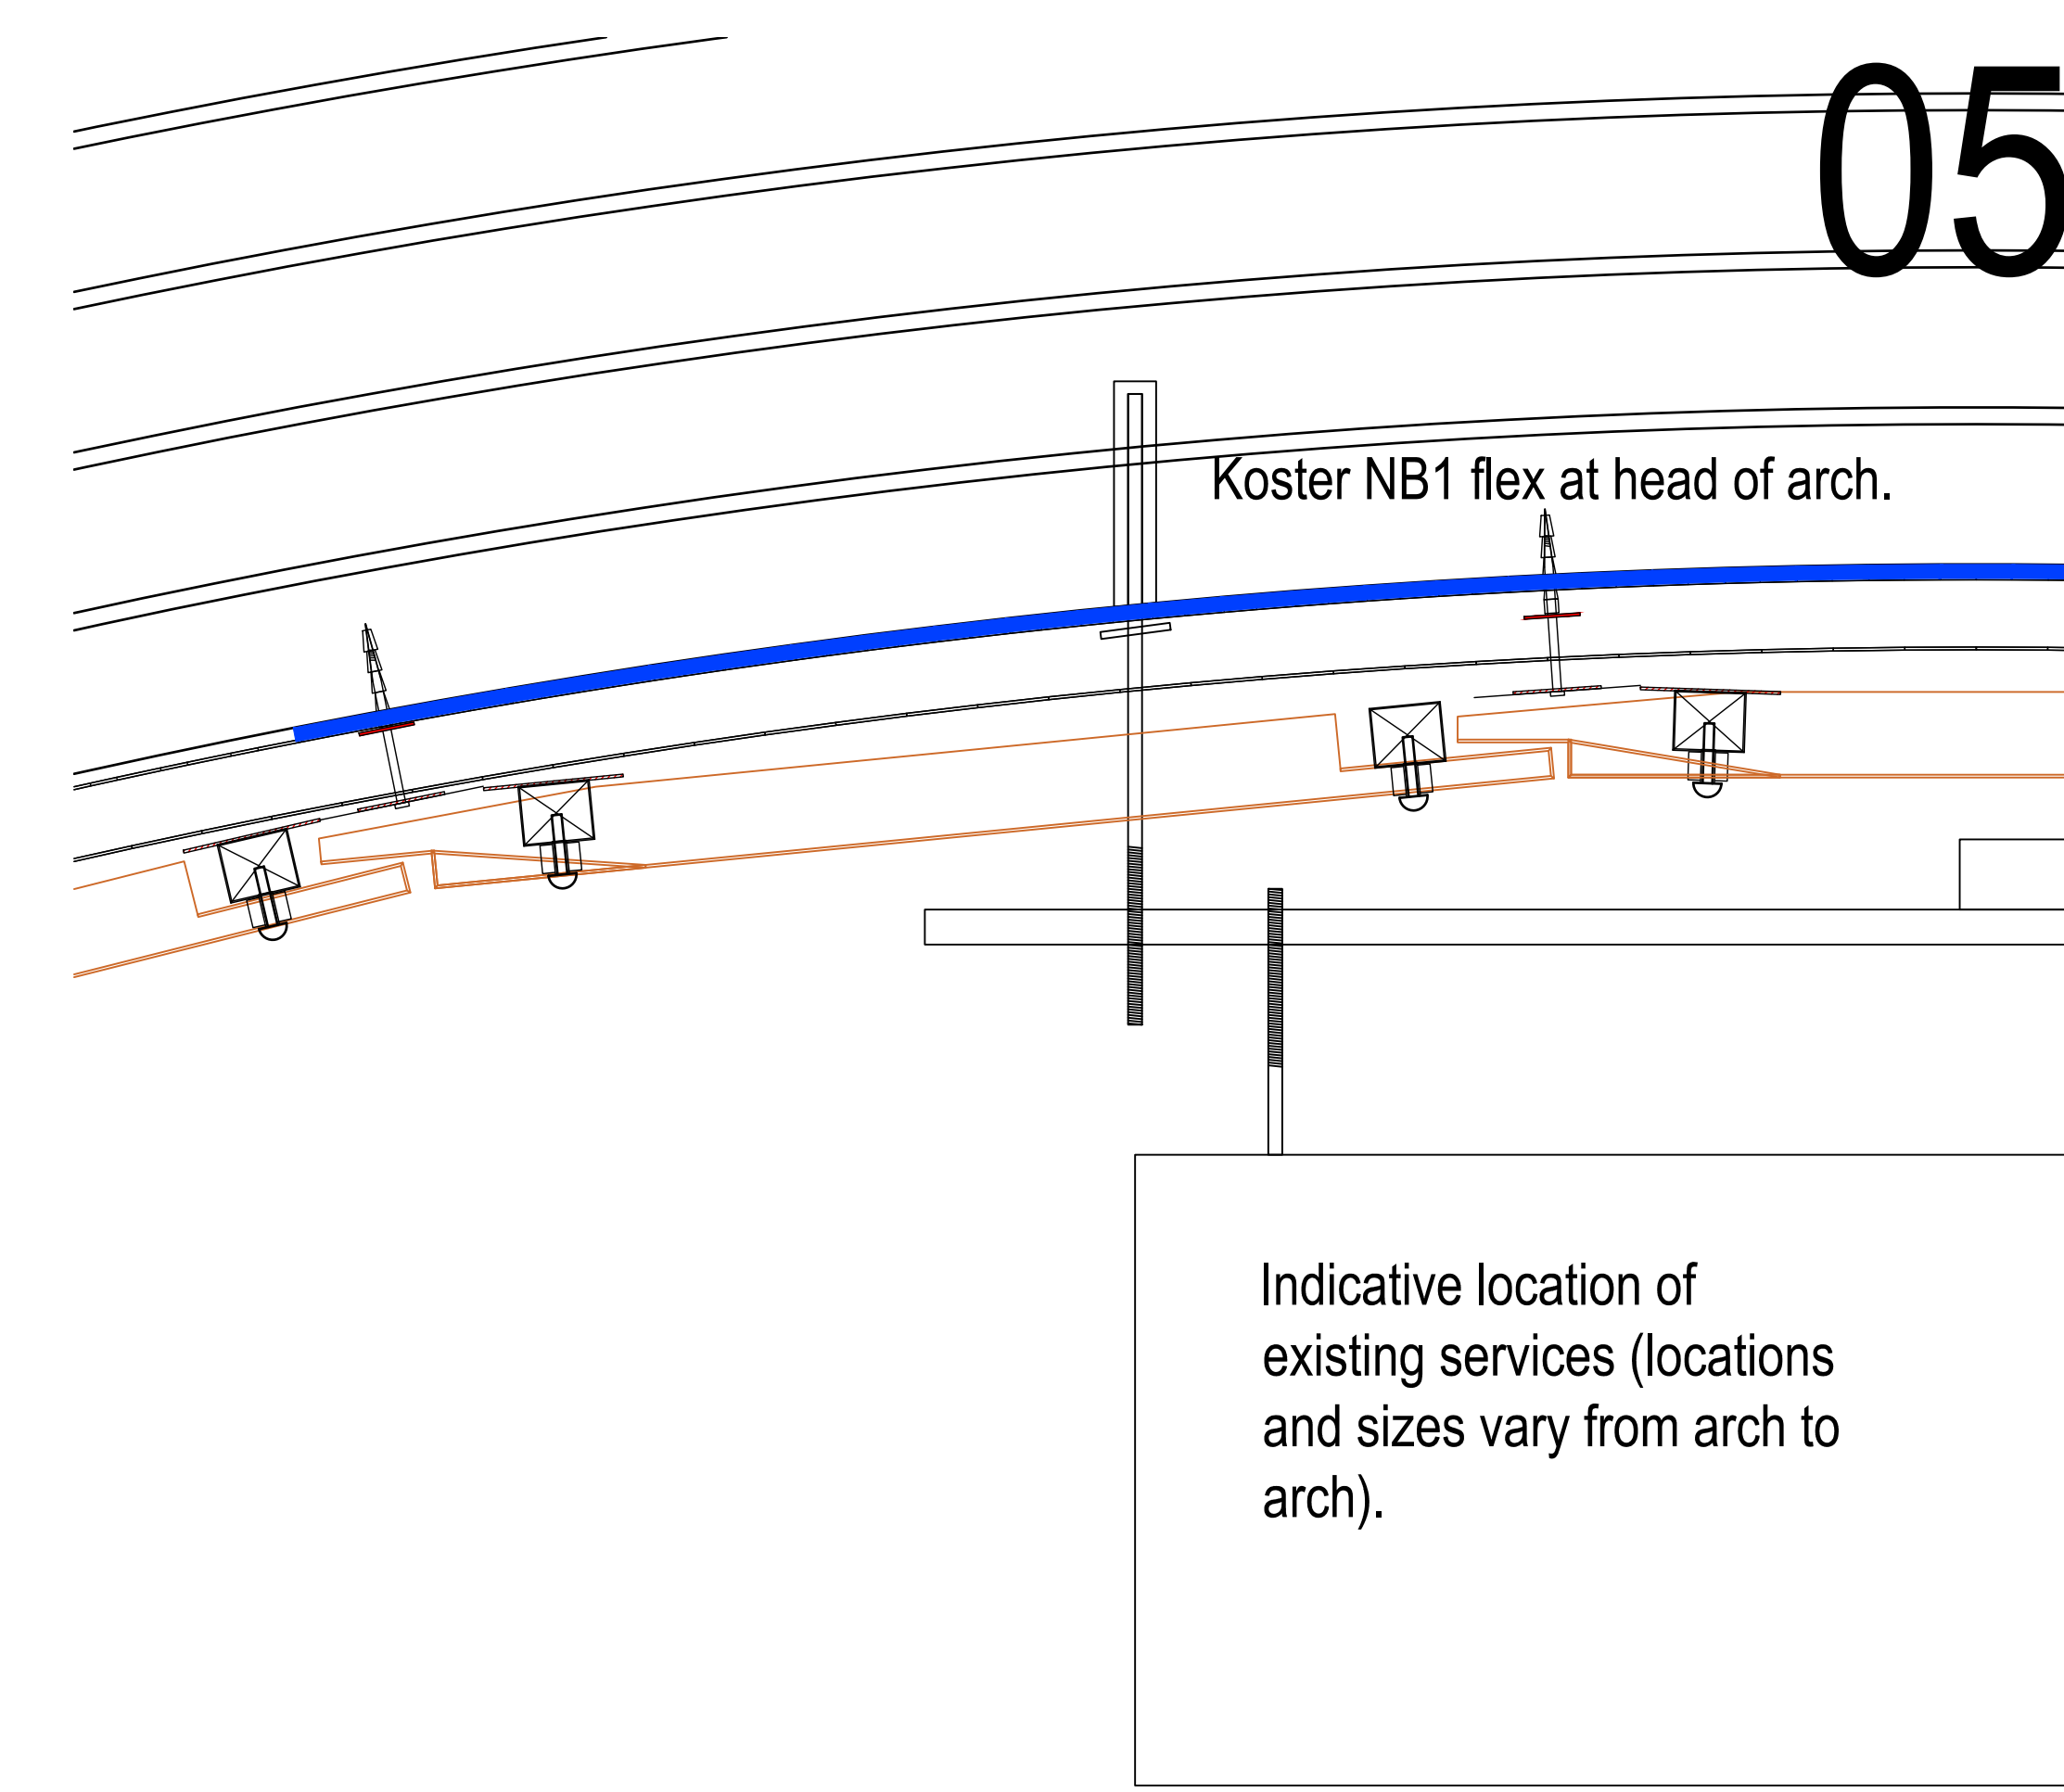
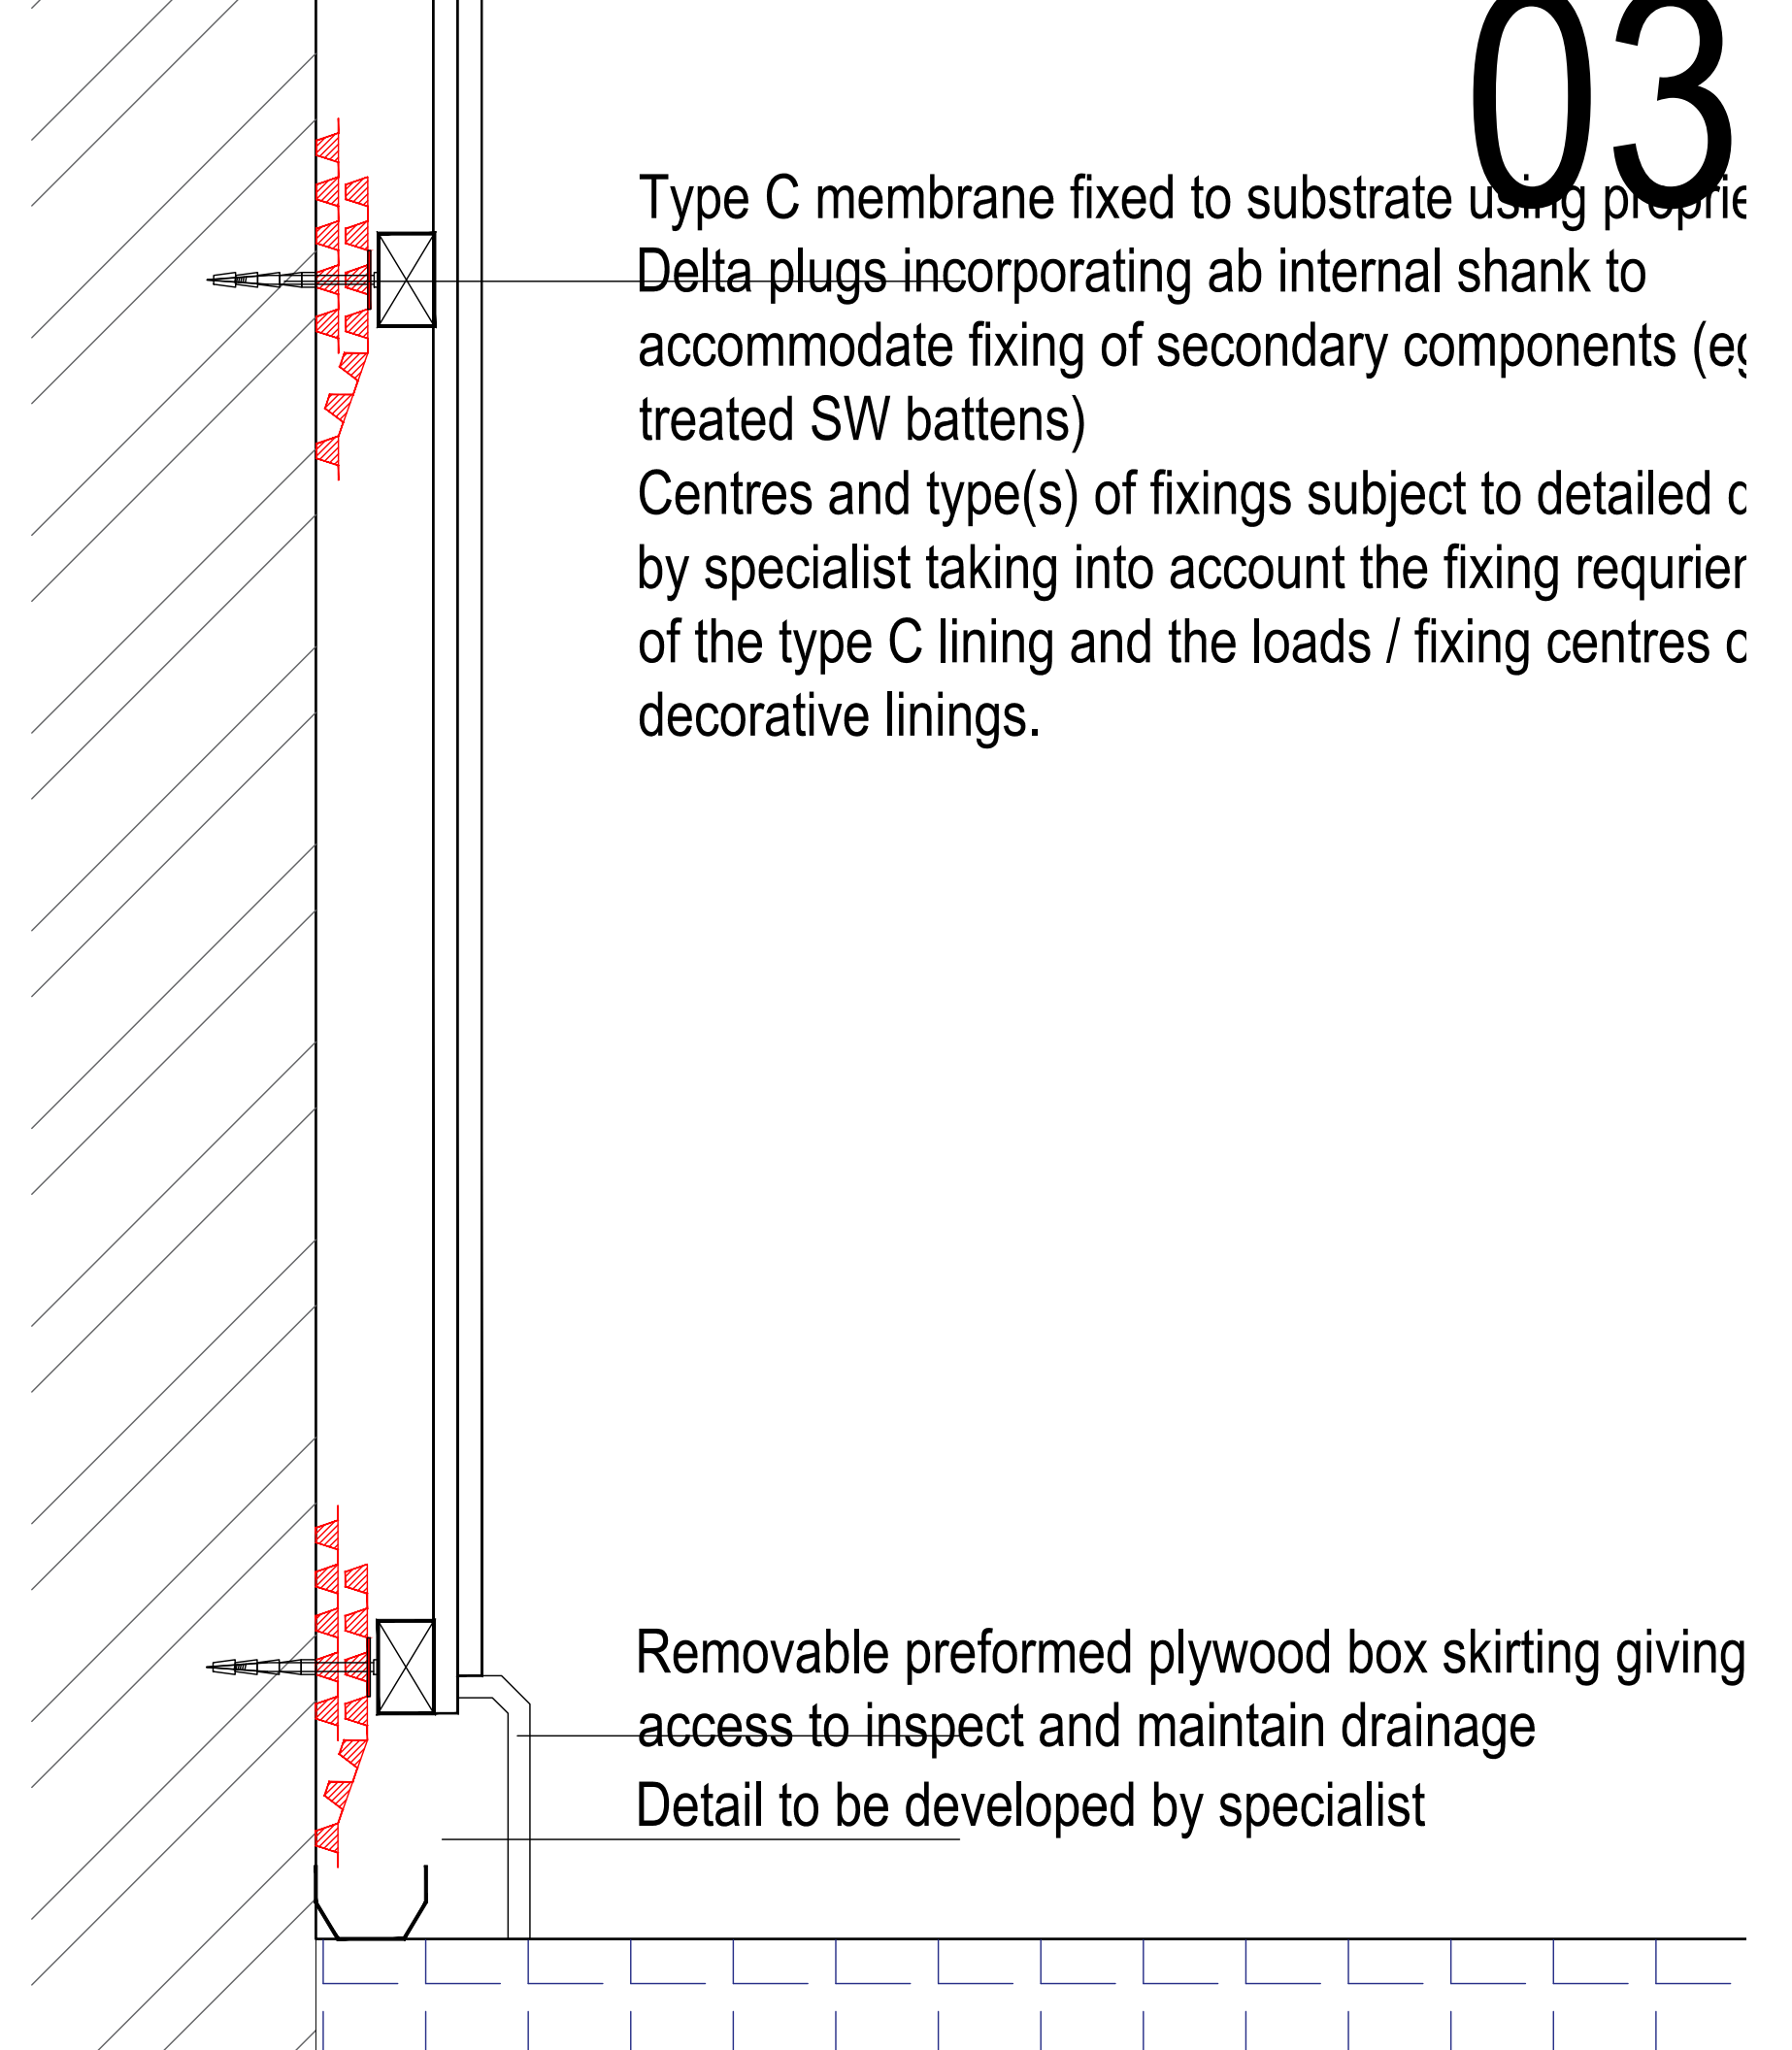
Rev	Date	Notes	By	Chk
P1	03.09.2023	Detail 5 added: Weep pipes added.	MAS	EW
P2	26.09.2023	Additional space allowed for gutter clearing	MAS	EW
P3	14.05.2023	Weep drain detail amended (100mm core drill holes)	MAS	EW
P4	26.06.2024	Timber framing to Sandstone Impost amended	MAS	EW
P5	26.09.2024	Additional drive added	MAS	EW
P6	22.07.2024	Detail 01 amended	MAS	EW
P7	10.02.2026	Type C lining omitted from soffit panels: weep holes omitted	MAS	JGBB
P8	16.02.2026	Type A lining reinstated at head of Arch soffit	MAS	JGBB
